Questions and Answers

Pictures

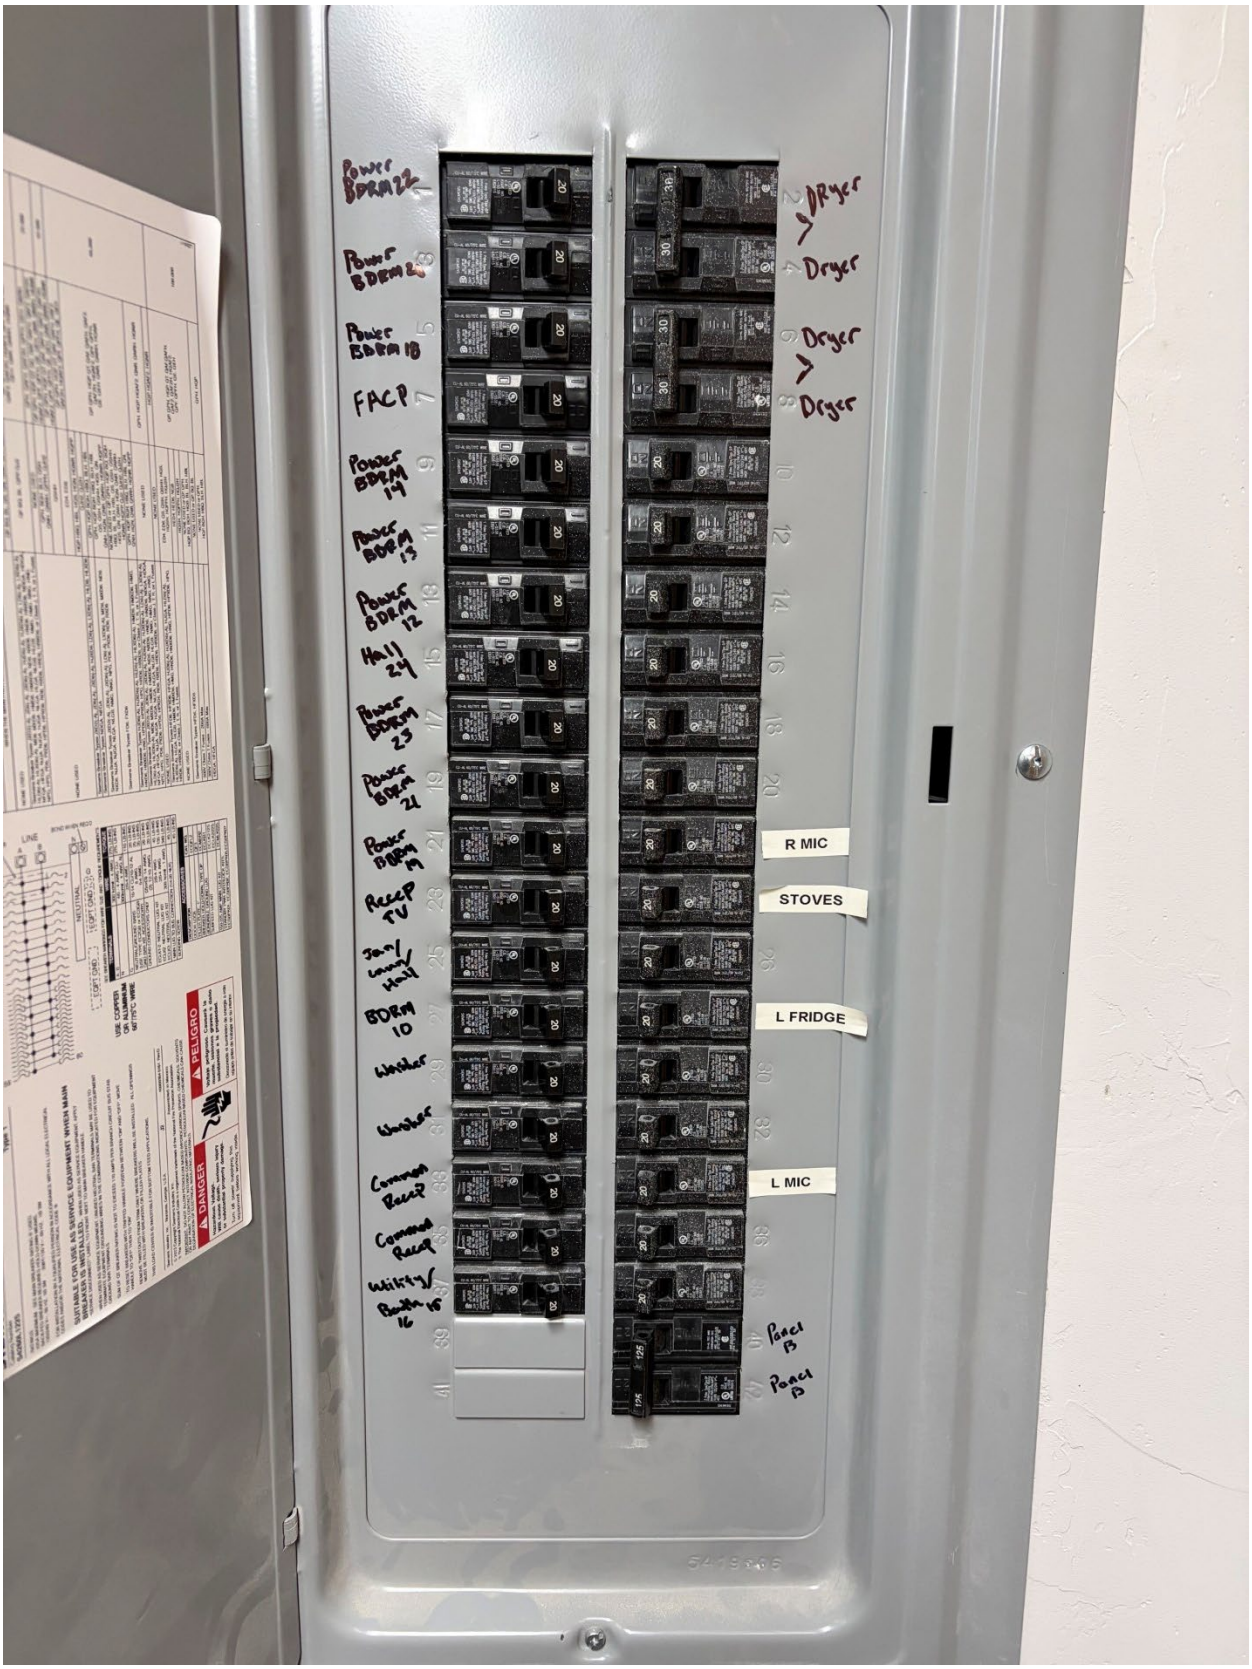
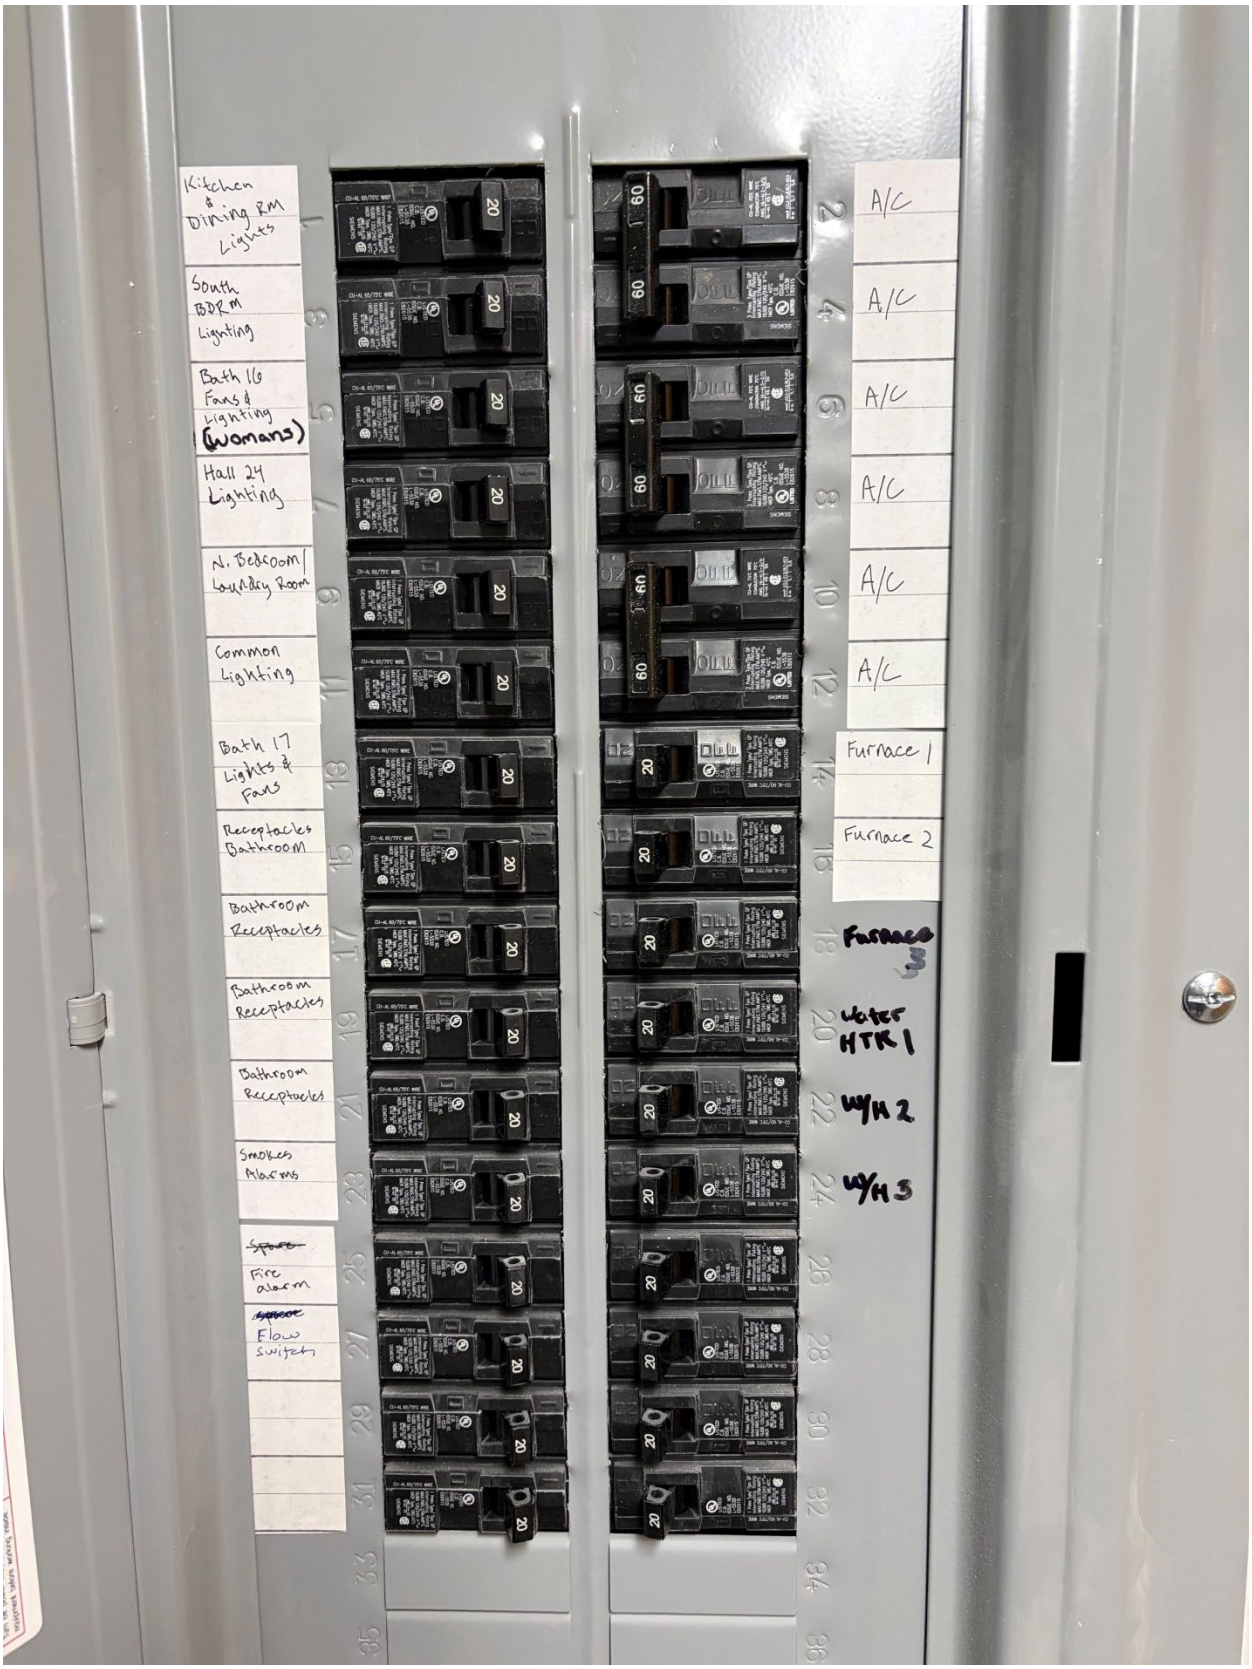
10. If drawings are unavailable, can the Government provide photographs of the existing installation, including the condenser, evaporator coil, equipment labels, cabinet dimensions, and site conditions?
    Photos will be provided of the existing AC unit, coil and existing furnace
